ADDENDUM #1

REQUEST FOR PROPOSALS FOR HILLCREST ROUNDABOUT EAGLE COUNTY, COLORADO

December 14, 2022

US 6 & HILLCREST ROUNDABOUT	
TOPSOIL QUANTITY	
Designer: CJK	STRUCTURE NUMBERS
Detailer: CJK	
Sheet Subset: TABULATION	EX-1

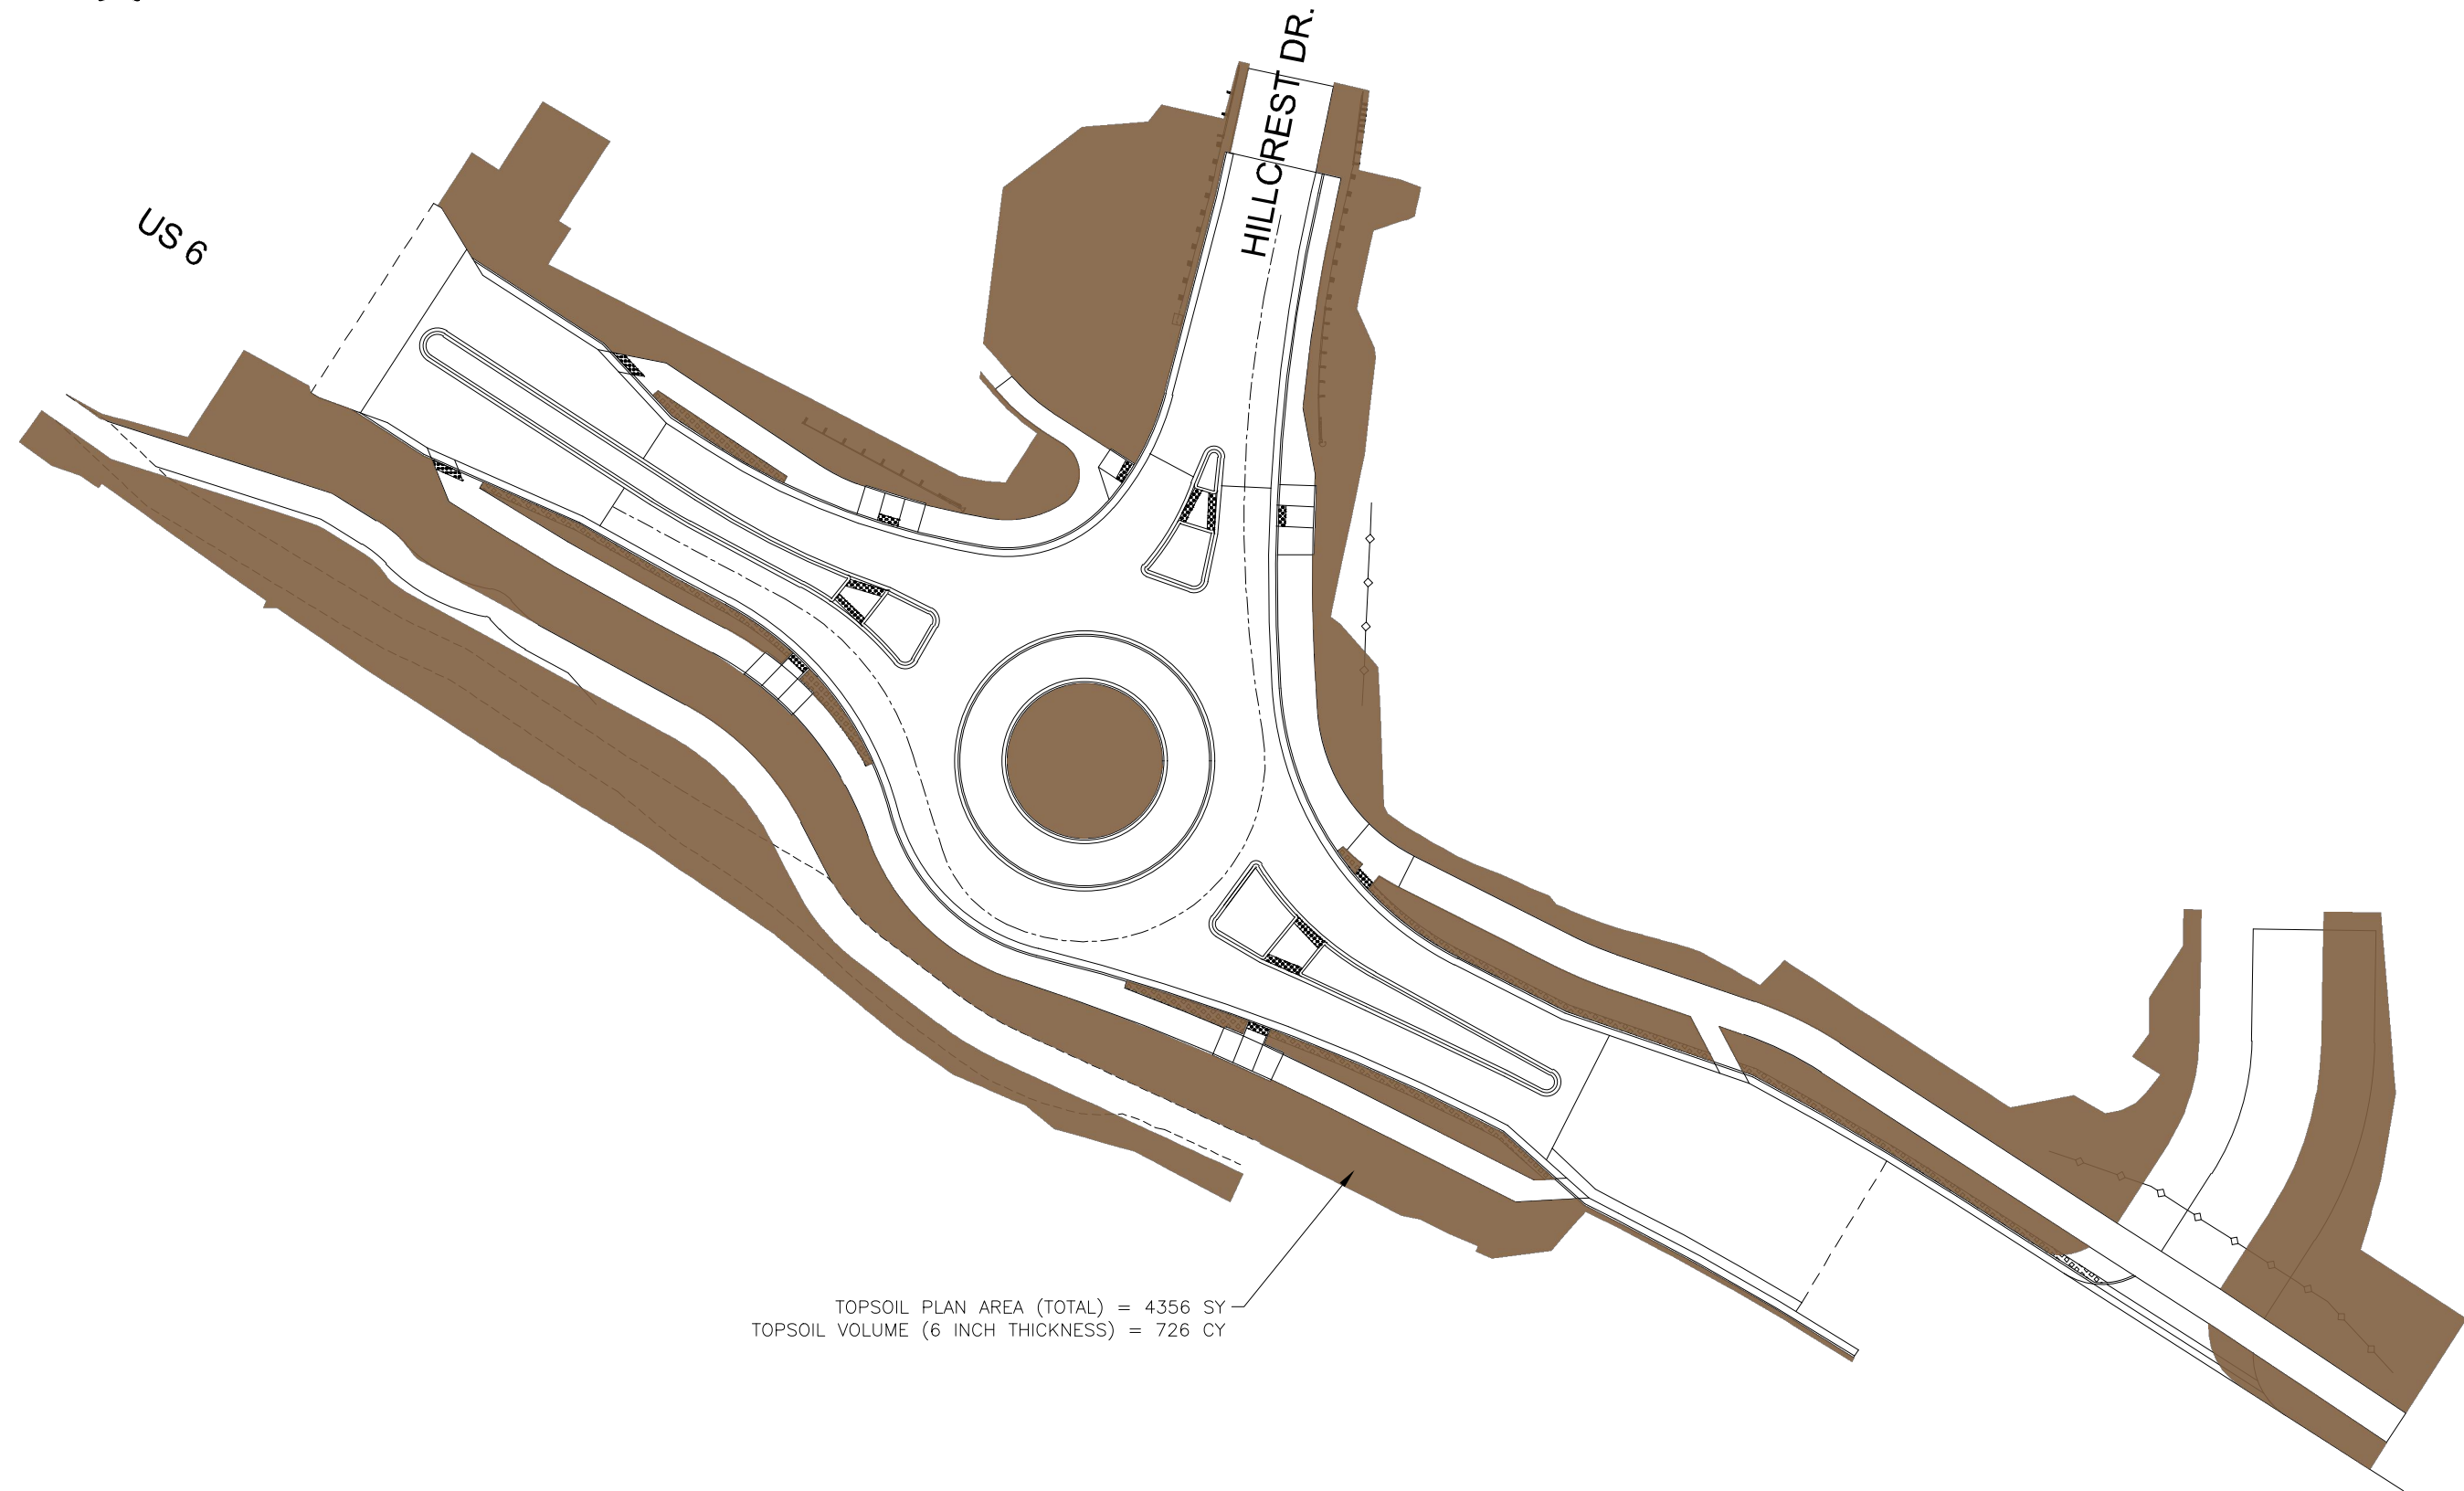
- 4. Can you verify the topsoil quantities? At 6", our take-off shows approx.. 660 CY but the Bid Quantity is 1023 CY.**
See attached exhibit on calculation of topsoil.

TOPSOIL PLAN AREA (TOTAL) = 4356 SY
 TOPSOIL VOLUME (6 INCH THICKNESS) = 726 CY
